工程指示 / 要求簡箋(E.I.)

工程指示編號：EI / 7196 / 23

工程名稱：將軍澳日出康城 11

工程項目：顧問上廠報告 (11/9-25/12) 精華版加完整版

Photo 7

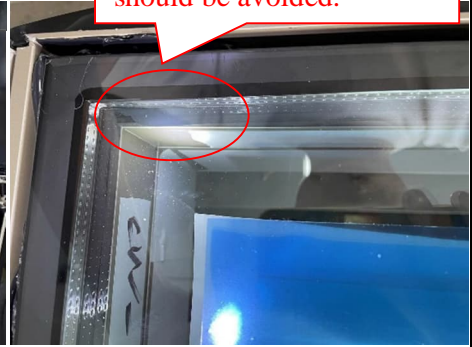
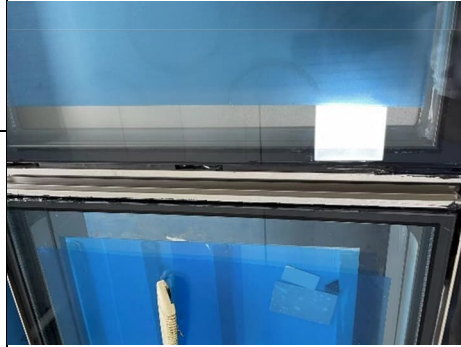
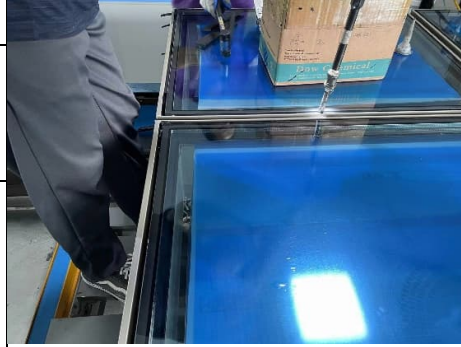
Apply structural sealant for T3 36/F to 40/F MO23

MIDI is reminded to carry out the remedial works prior products delivery and to improve workmanship for future works

#1:
黑膠過多，影一條手工好的

Photo 9

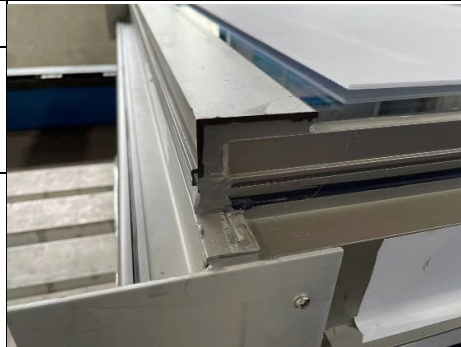
Description:
Water test for unitized panel No. AF-049 T3 38/F MO23

Action:
MIDI is reminded to find out the reason and test again.

Water entered the back panel.

#2:
單元件AF-049 T3 38/F MO23
漏水，俾試水報告。
